# PERMIT

## SEWAGE DISPOSAL SYSTEM

HOWARD COUNTY HEALTH DEPARTMENT

REPAIR - PURPOSE ---Septic System Has Failed.

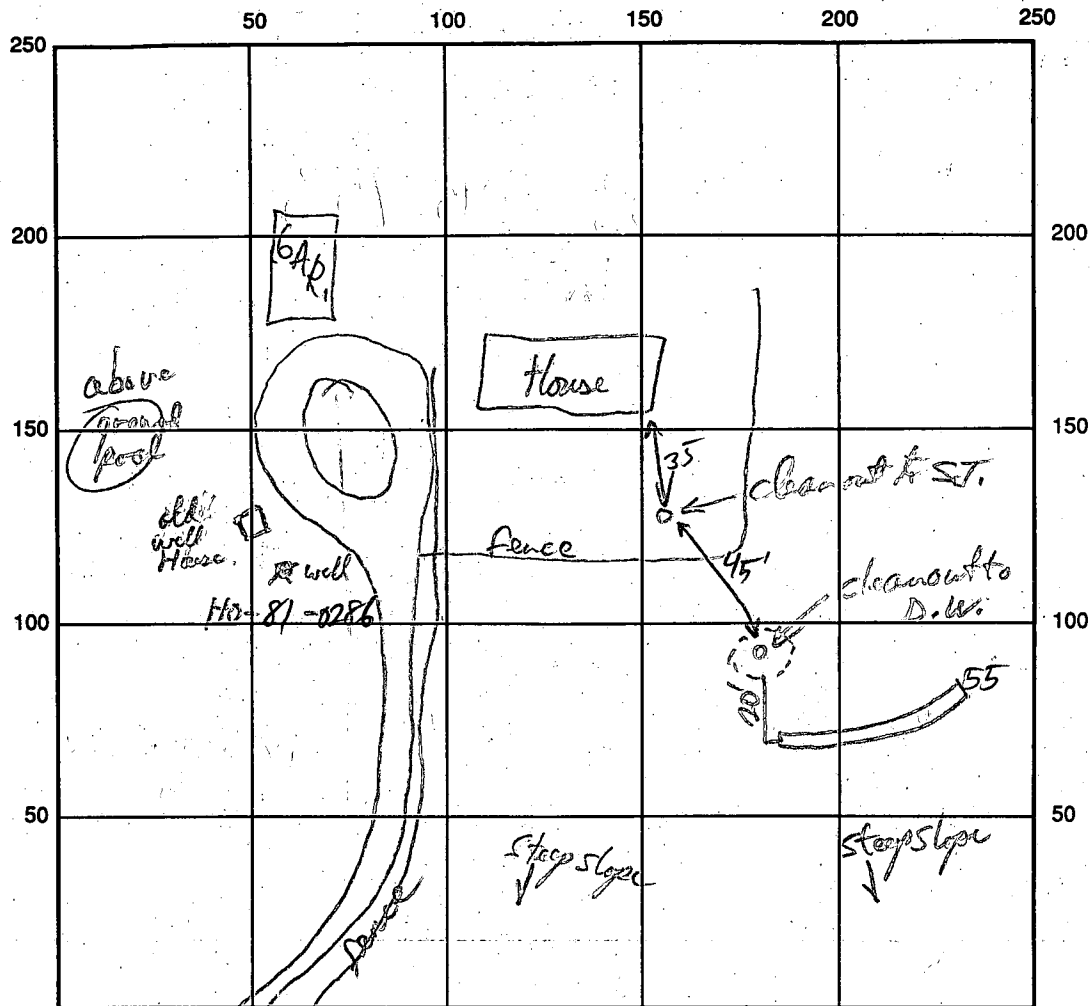
Call for inspection when ground is opened so sanitarian can recommend repair. 04/06/94

Install one 58 ft long, 2 ft wide, 10 ft deep, inlet to 3', 7 ft stone fill  
Trench. Connect through existing dry well.

SEPTIC TANK LEVEL existing CLEANOUTS existing ST., D.W.  
 DISTRIBUTION BOX LEVEL NA. one trench connected thru dry well  
 DRAIN FIELD/TITLE DEPTH 10 FT. TRENCH WIDTH 2 FT. INLET DEPTH 3 FT.  
 EFFECTIVE GRAVEL DEPTH 7 FT. TOTAL LENGTH 55 FT.  
 NUMBER OF TRENCHES 1 ONE SIDEWALL/BOTTOM AREA 385 SQ. FT.  
 DRYWALL INSIDE DIAMETER        FT. EFFECTIVE DEPTH BELOW INLET        FT.  
 ABSORBENT AREA        SQ. FT.

REMARKS: OK to continue around hill in trench. RFP 4/13/94 Call for final design when ready  
OK to cover RFP 4/15/94
